MILITARY SPECIFICATION
VALVES, REGULATING FLUID PRESSURE

This amendment forms a part of MIL-V-5519D, dated 10 Jan 75, and is approved for use within the Department of the Air Force and is available for use by all Departments and Agencies of the Department of Defense.

FIGURE 1. Set-up for operating pressure range and endurance tests.

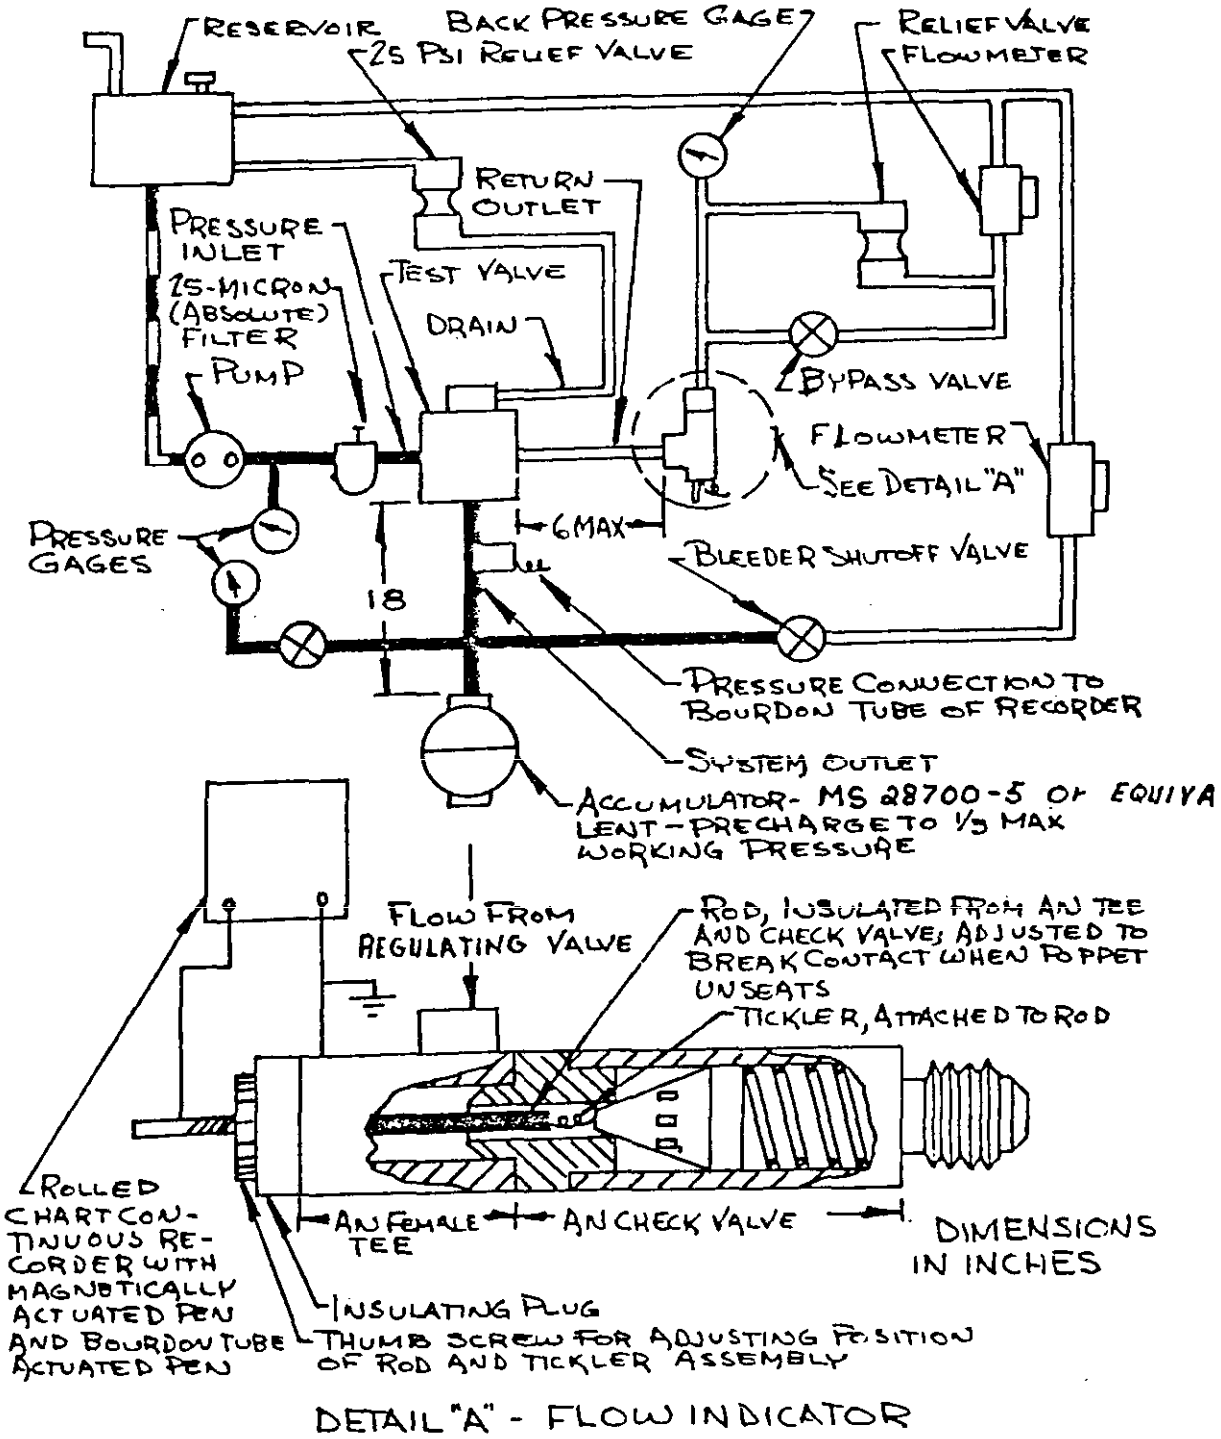
Figure 1: Delete and add new figure 1. Figure 1 forms page 5 of this amendment.
